Topic

The design adaptation of the gas distributor ensures that the gas distributor is easier to install.
From now on, only the new adapted gas distributors from RATIONAL will be installed and shipped (service parts).
Gas distributors already in stock can be installed.
Already installed gas distributors do not need to be replaced.
NOTICE! Furthermore, a leakage and flue gas test must be carried out after each replacement of gas components.

- iCombi Pro / iCombi Classic Gas
- 10-1/1

Component	Article number
Gas distributor	70.01.607S

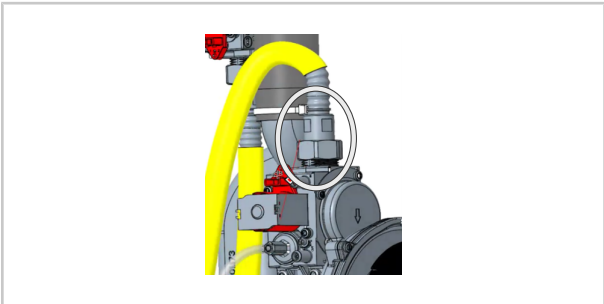
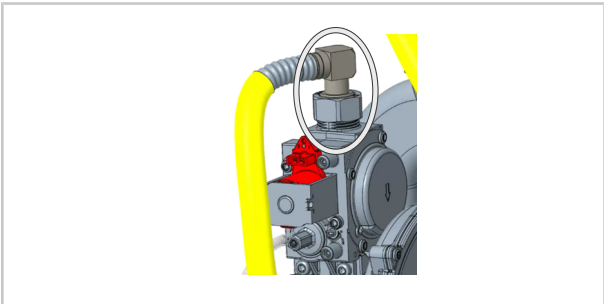
NOTICE! The tightening torque is 25 Nm [18.5 lbf ft] before and after the design adjustment.
OLD:

NEW:

No further action is required.
